Agenda Date: September 29, 2022
Item Number: E7

Docket: PG-220683
Company Name: Cascade Natural Gas Corporation

Staff: Scott Anderson, Pipeline Safety Engineer

Figure 1: Overall view of the proposed Zillah HP Replacement (Green) and existing Zillah HP (Yellow) alignment.

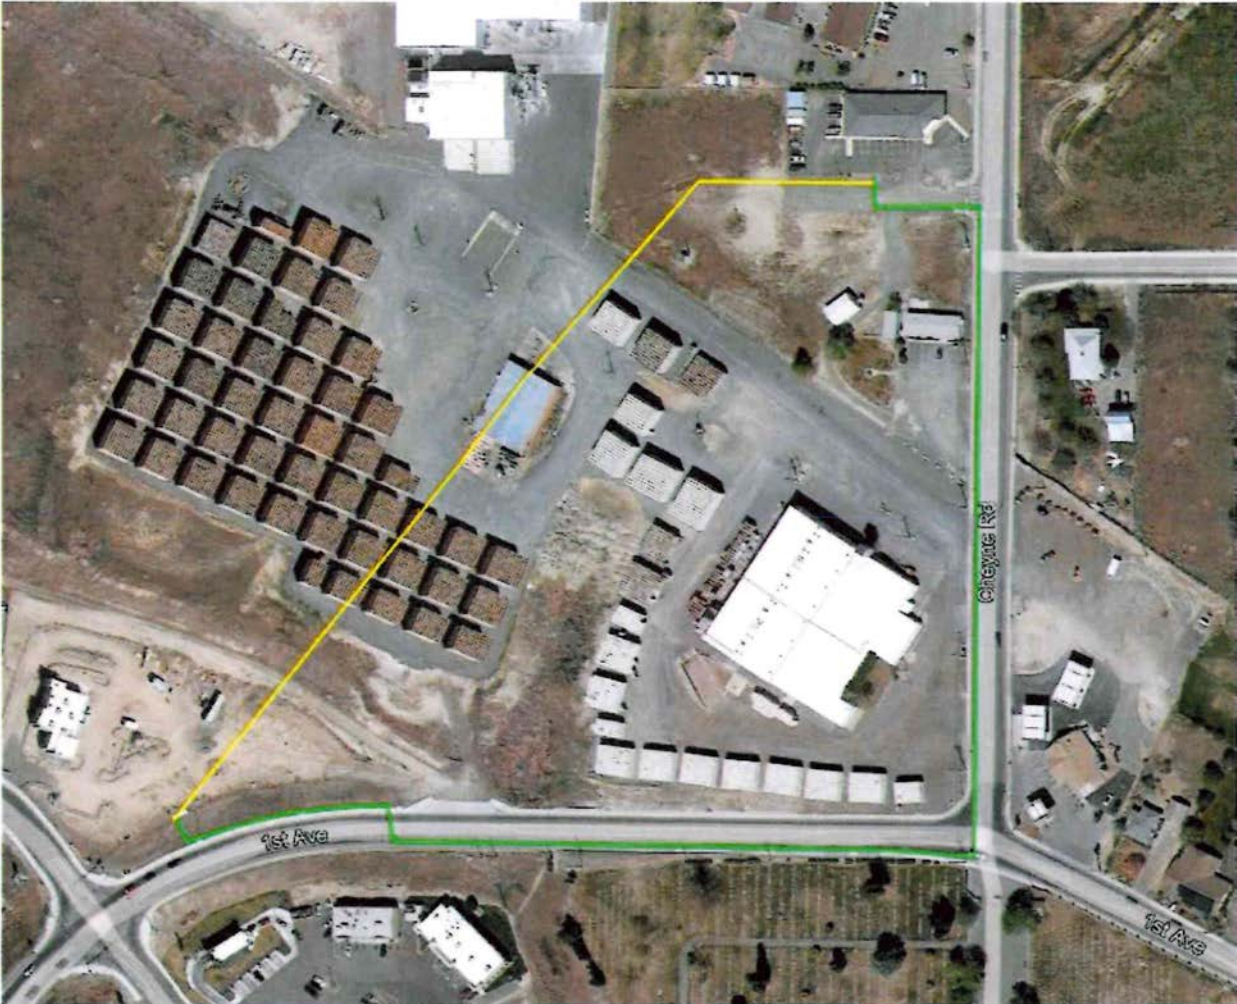
Issue an order granting Cascade Natural Gas Corporation's (Cascade or Company) request to construct and operate approximately 2105 feet of new 6-inch steel main in Zillah, Washington, as proposed in Cascade's Proximity Considerations Request dated September 12, 2022. This will connect to the existing 6-inch Toppenish-Zillah HP pipeline that operates at an MAOP of 400 psig and replaces a section of the existing pipeline between Collins Ln and Vintage Valley Pkwy. The complete route of this line is depicted on the attached aerial maps located in Appendix A.

Figure 2: Section of the proposed pipeline showing buildings 1-11 within the 100-foot proximity boundary.

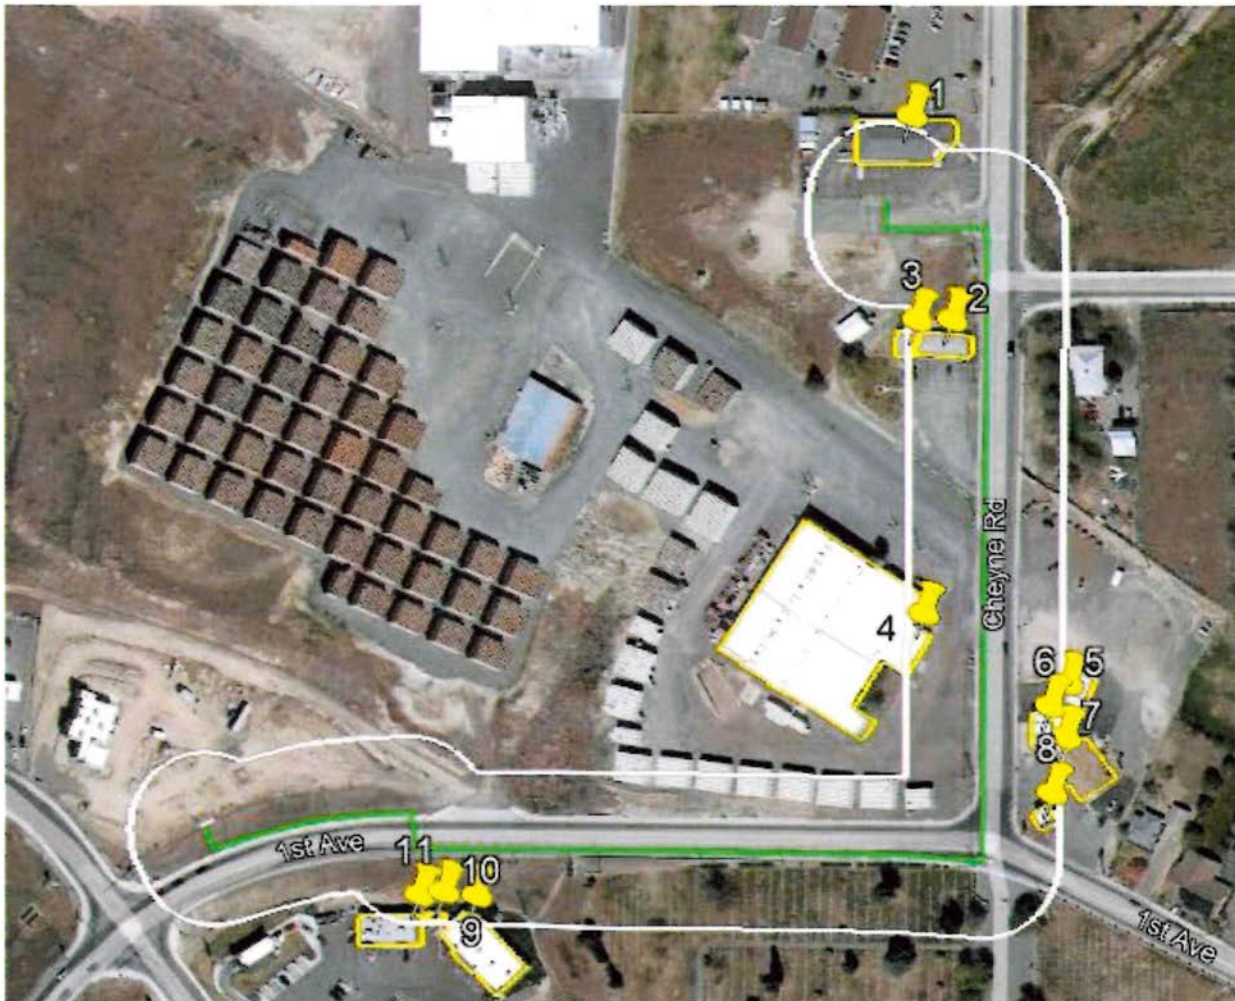
- (d) The approximate distance from the pipeline to the existing structures ranges from 19 feet to 100 feet. All other buildings along the route are greater than 100 feet from the pipeline.
- (e) At the proposed MAOP of 400 psig the stress level of the new pipe and fittings will be a maximum of 9.10 percent of the specified minimum yield strength.
- (f) The proposed pipeline and fittings will be pressure tested to a minimum of 750 psig for 24 hours in accordance with the Company's procedures prior to operation. This test pressure is at least 1.5 times the MAOP of the pipeline as required for a Class 3 location.
